SUBJECT: Addendum No. 1
City of Lookout Mountain, GA
Chickamauga Trail Pump Station Improvements

ADDENDUM NO. 1

CHICKAMAUGA TRAIL PUMP STATION IMPROVEMENTS

CITY OF LOOKOUT MOUNTAIN, GEORGIA
GEFA LOAN NUMBER: GF2024017
CTI PROJECT NO. G24017-01

PUMP STATION TOP PLAN
SCALE: $\frac{3}{8}" = 1'-0"$

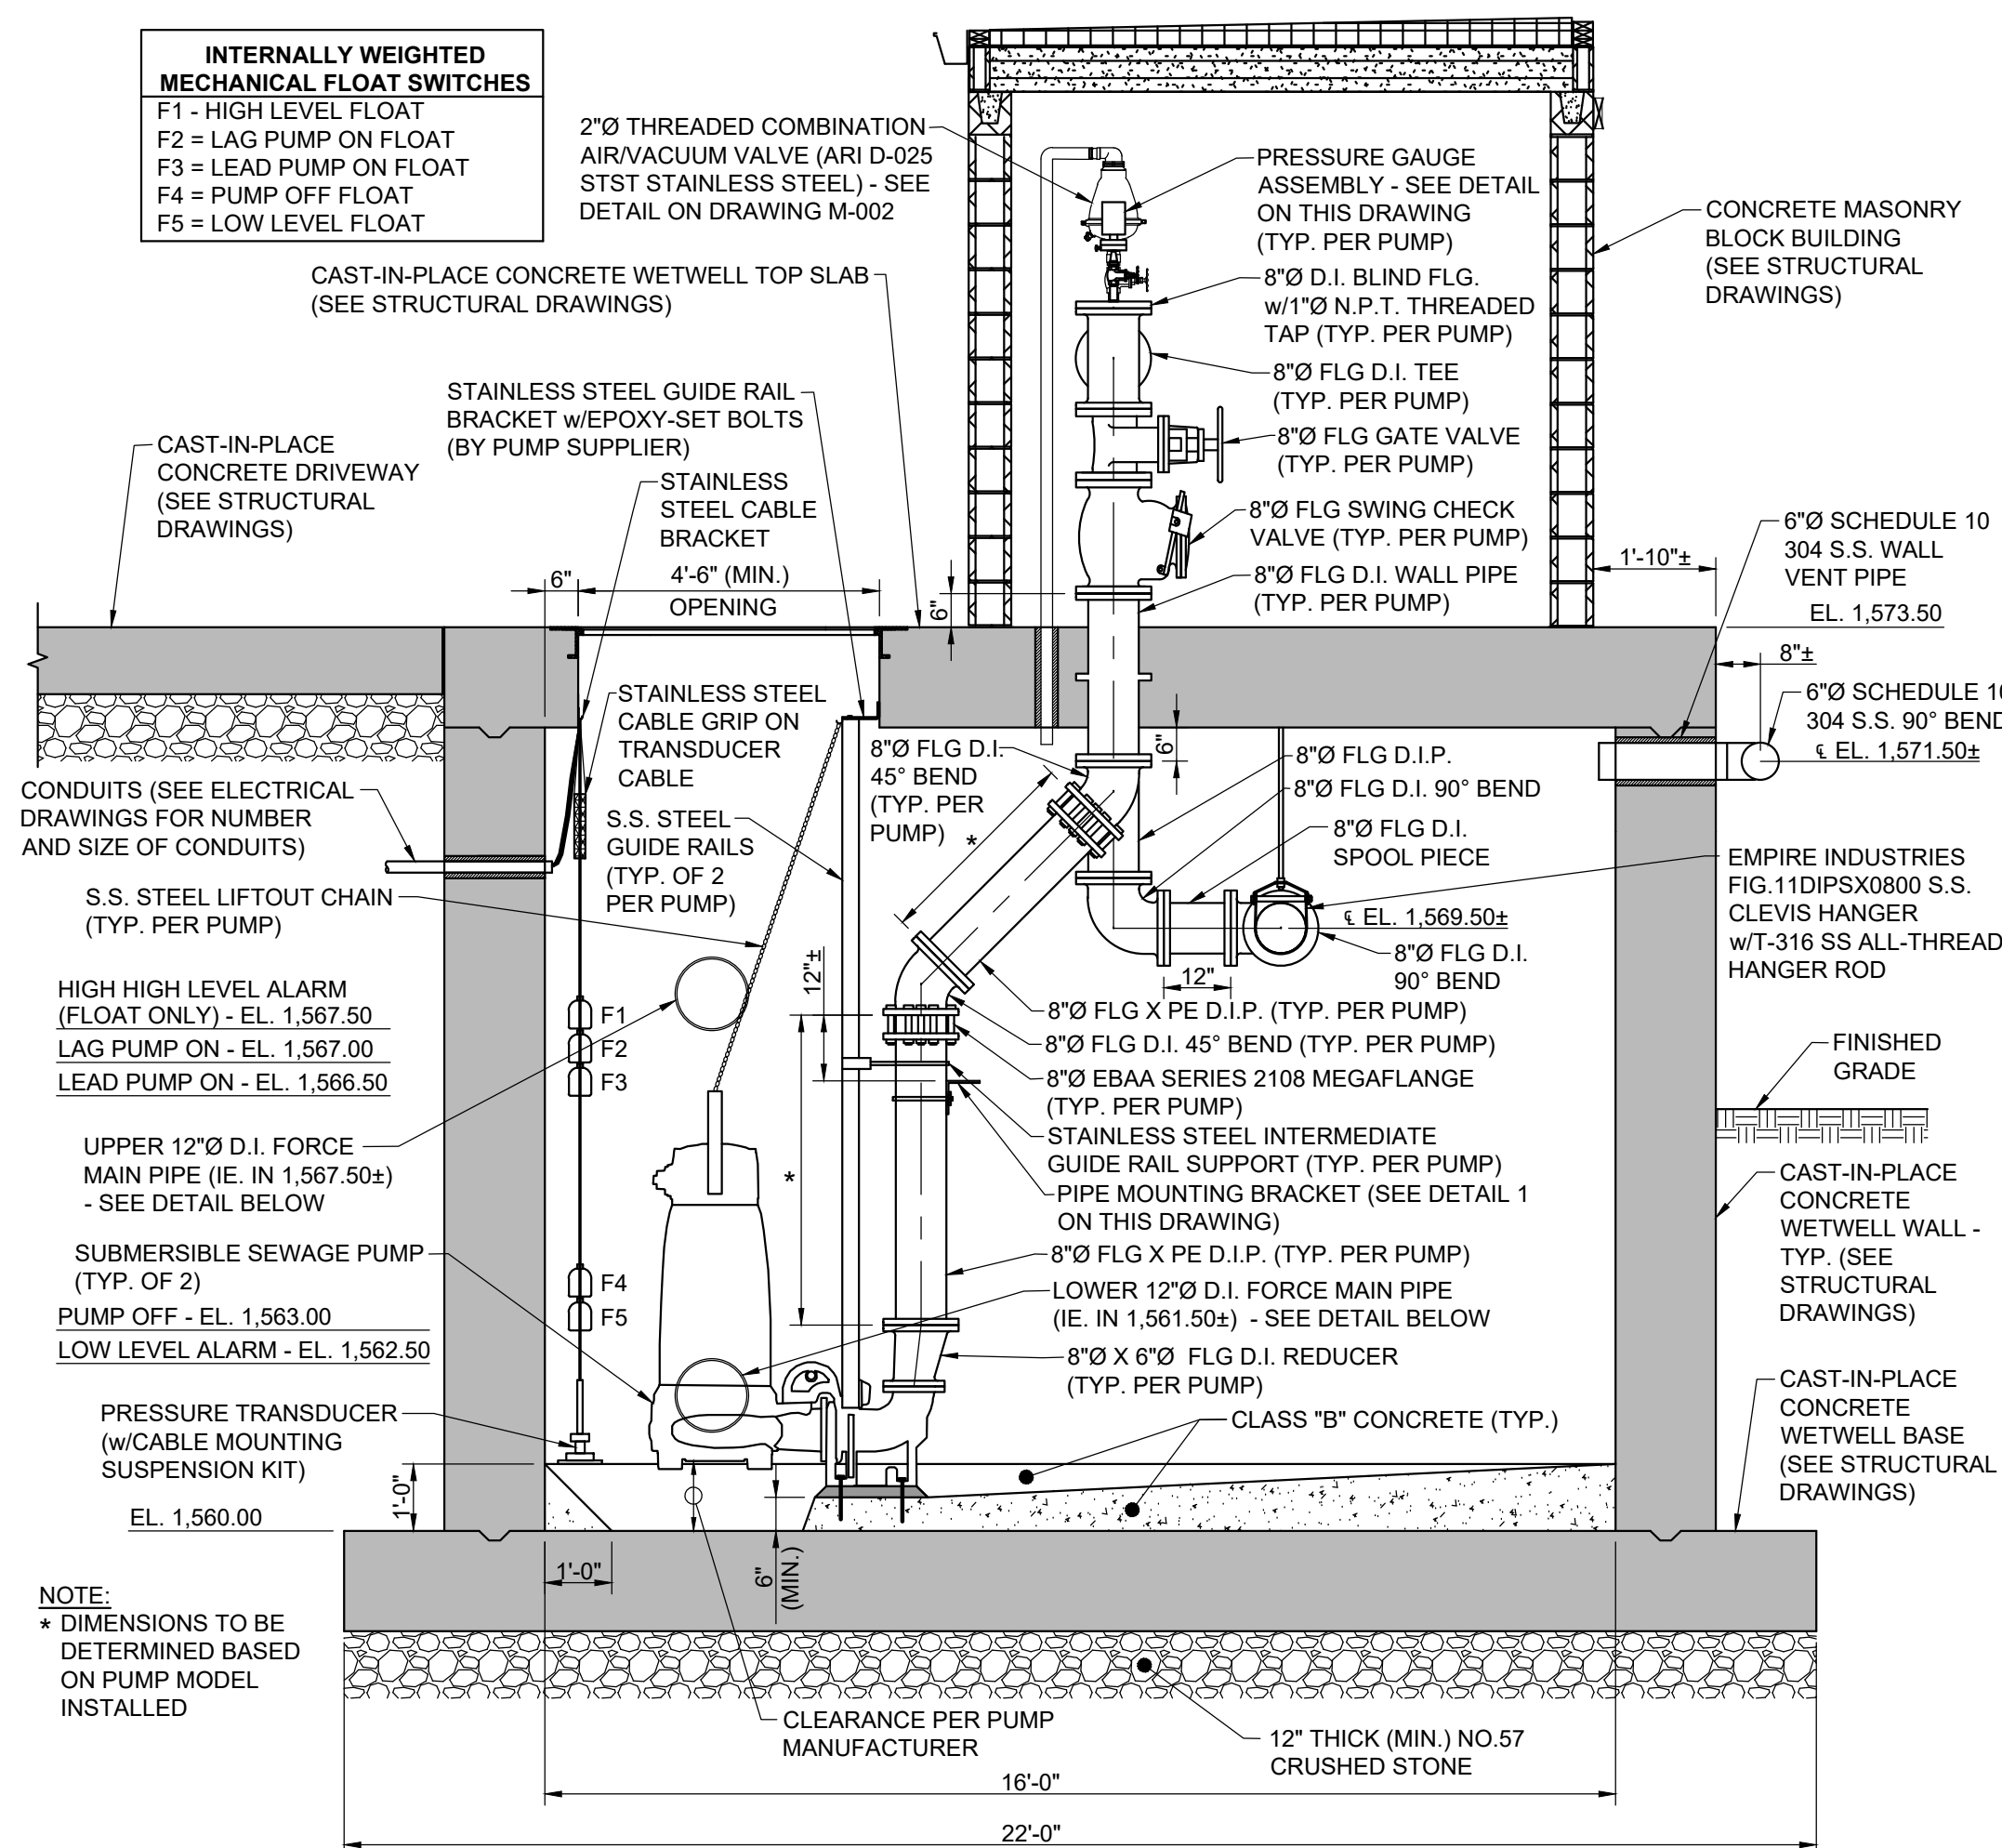
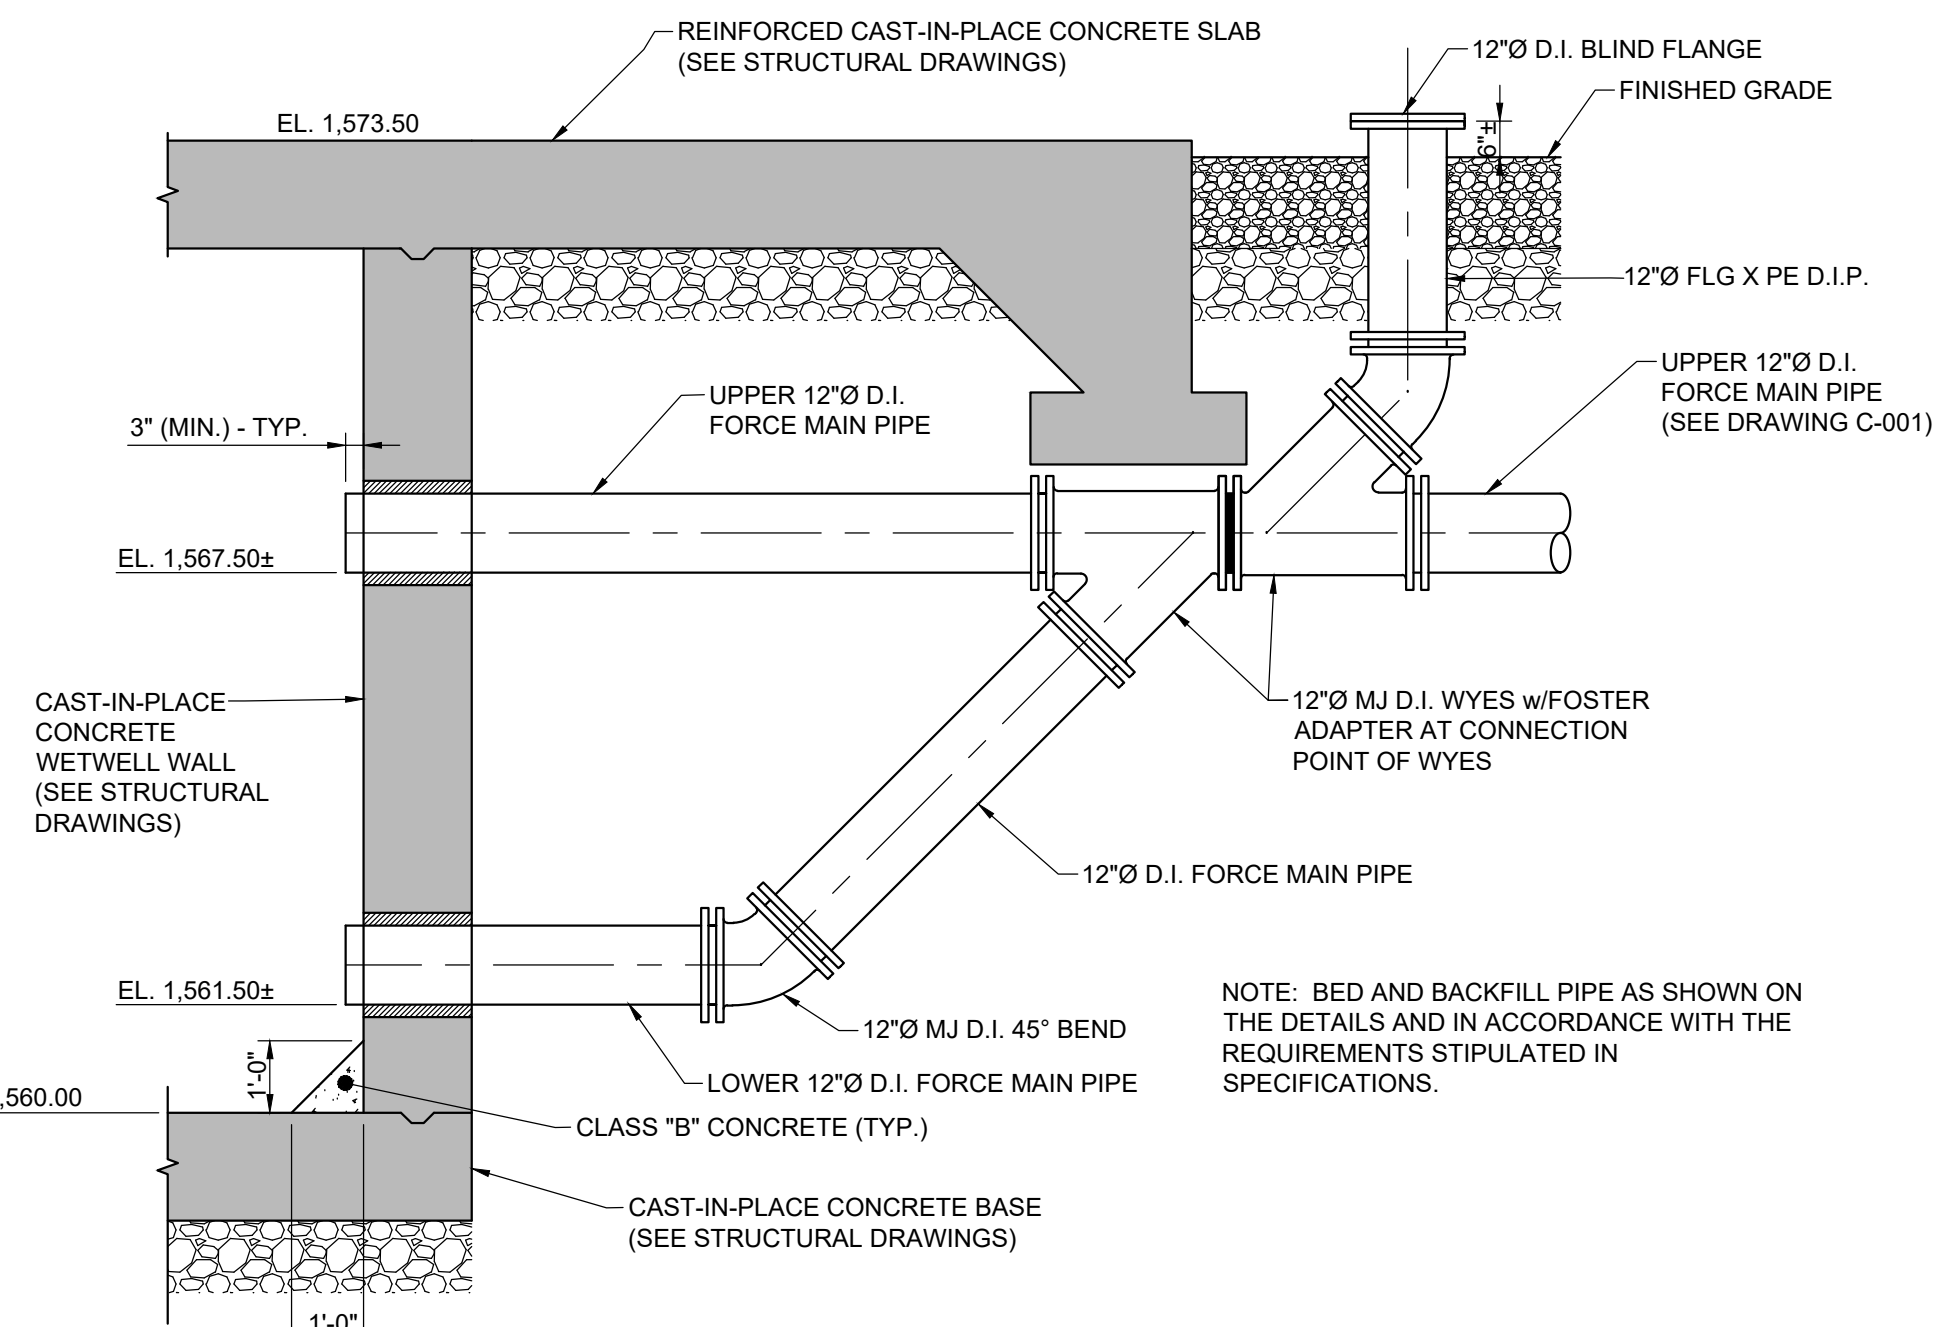
REVISIONS				
NO.	DESCRIPTIONS	DATE	BY	APPD
1	LENGTHENED MASONRY BUILDING	08/25	DDT	DDT
